CNL-17-100

Clinch River Nuclear Site
NRC Docket No. 52-047

Subject: Response to Request for Additional Information Number 5, Questions 02.05.01-03 and 02.05.01-05, Regarding Basis Geologic and Seismic Information in Support of Early Site Permit Application for Clinch River Nuclear Site

Enclosure 1
Response to NRC RAI Number 5, Question 02.05.01-03

Figure 2.5.1-88 (Sheet 1 of 2) Geologic Map of the 1983 CRBRP Excavations

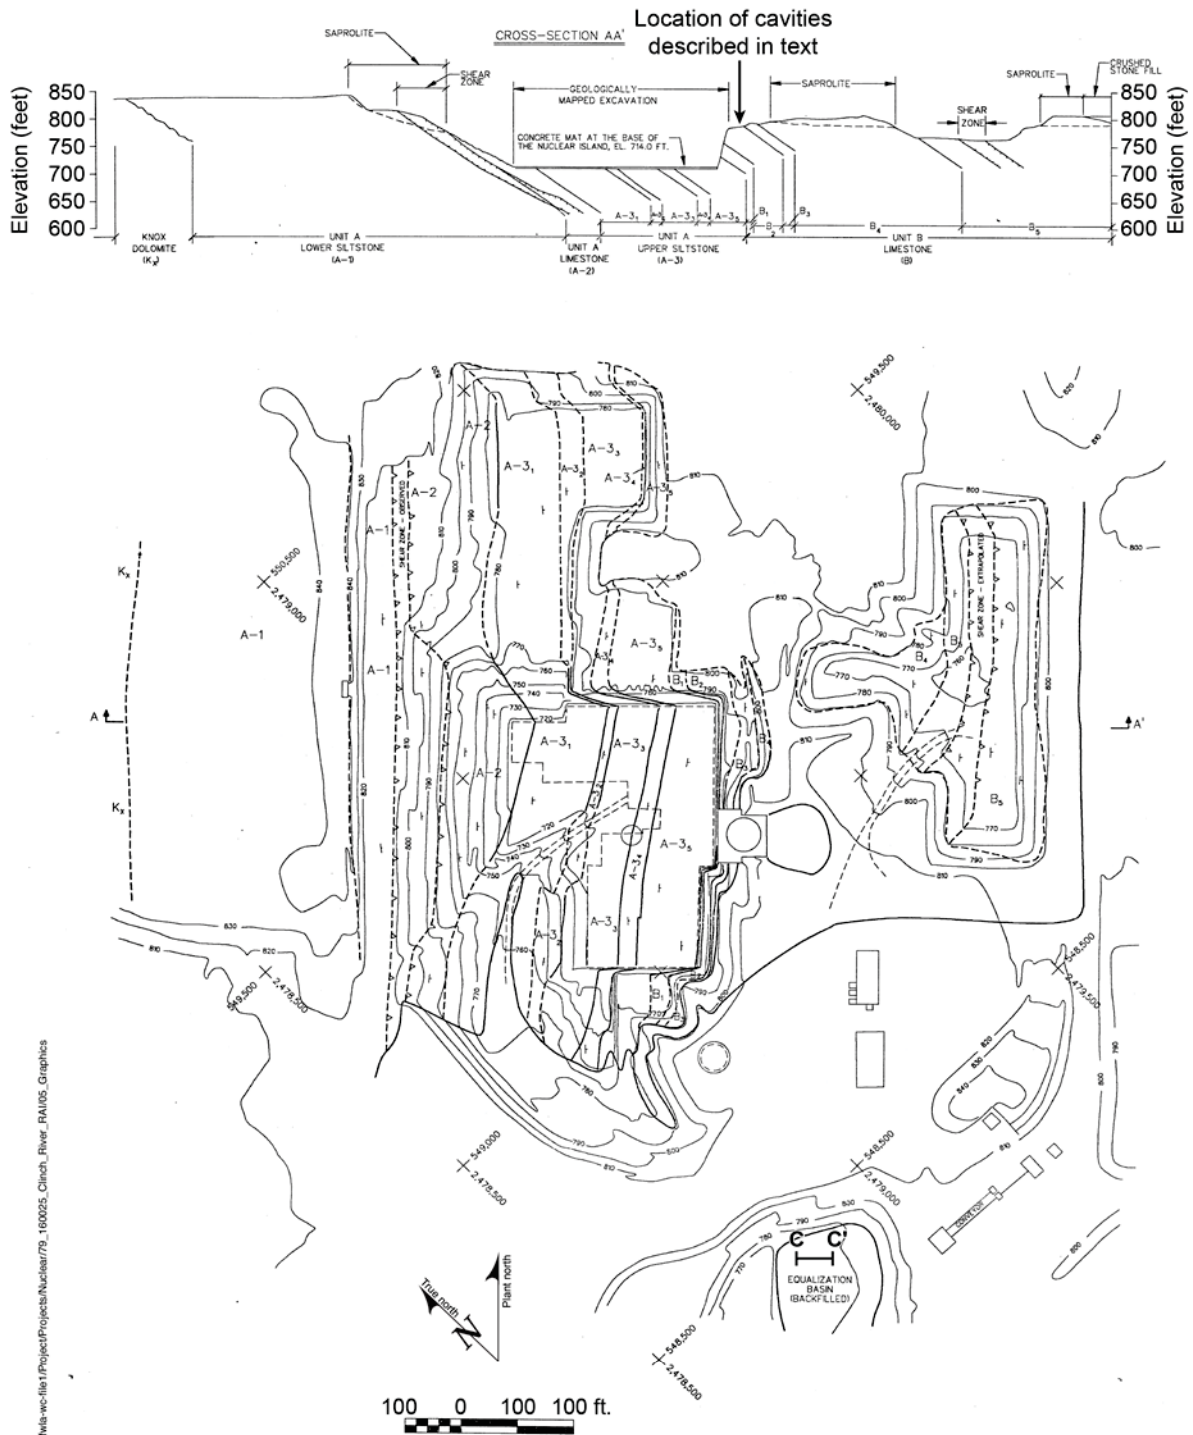
- b. The SSAR (Rev 0) 2.5.1.2.5.1 CRN site karst conceptual model indicates under item 9: "Evidence of hypogene processes is not documented at the CRN Site". The SSAR indicates that some deep phreatic groundwater circulation may be occurring in the Chickamauga carbonate rock beneath the ORR area, and dissolution conduits and cavities may be present to depths of more than 800 ft. (Reference 2.5.1-213, Ausich & Meyer, 1990). Although not discussed in the karst conceptual model, other sections of the SSAR have discussed other possible instances of hypogene karst systems in the area such as: Doll et al, reference 2.5.1-244, 2.5.1-245; TDEC hydrogeologists reference 2.5.1- 299; Nativ and others, reference 2.5.1-300 and 2.5.1-301; Wolf et al., 1997. Please provide a discussion of the potential for hypogene systems or features at the CRN site within TVA's conceptual model which also includes relevant information from these citations.*

In addition, a discussion of geologic mapping of the excavation conducted in 1983 for the Clinch River Breeder Reactor Project (CRBRP) is being added as indicated in the SSAR markups below to SSAR Subsection 2.5.1.2.5.1.2 to aid in the understanding and assessment of karst hazards at the CRN Site. The excavation mapping was presented in a report by Drakulich (SSAR Reference 2.5.1-303). The excavation mapping report provides direct observations of weathering and karst features in the Fleanor member and Rockdell Formation. In the interest of providing a more complete assessment, a discussion of karst dissolution features exposed in the excavation, including illustrations excerpted from the report, is being added as indicated in the SSAR markup below in Subsection 2.5.1.2.5.1.2, "Karst Processes and Features at the Clinch River Nuclear Site," Subheading "*Karst Features in the CRBRP Excavation.*" The SSAR Subsection 2.5.1 markups reflect changes provided in TVA's letter CNL-16-162, "Submittal of Supplemental Information Related to Geologic Characterization Information, Surface Deformation and Stability of Subsurface Materials and Foundation in Support of Early Site Permit Application for Clinch River Nuclear Site," dated October 21, 2016. The SSAR markups will be incorporated in a future revision of the early site permit application.

The results of the CRBRP site investigation can be used to enhance and further inform the understanding of the geology and engineering suitability of the CRN Site. Excavations for the CRBRP were virtually complete before the project was cancelled in November of 1983. The excavations were mapped and described in detail prior to backfilling to provide documentation of the geology and structure exposed during the excavation (Reference 2.5.1-303) (Figure 2.5.1-88). Two excavations were made, a large excavation (480 ft long x 360 ft wide, and 100 ft deep) for the nuclear island (Figure 2.5.1-54) and a smaller excavation (180 ft x 180 ft shallow depth) for the Equalization Basin. The nuclear island excavation extended to an elevation of 712.5 ft MSL, with 75-ft-high near-vertical faces on the north, east, and south sides, and a 26-degree slope on the west side (References 2.5.1-100, 2.5.1-246, and 2.5.1-257).

New SSAR Figure 2.5.1-88 is added to SSAR 2.5.1:
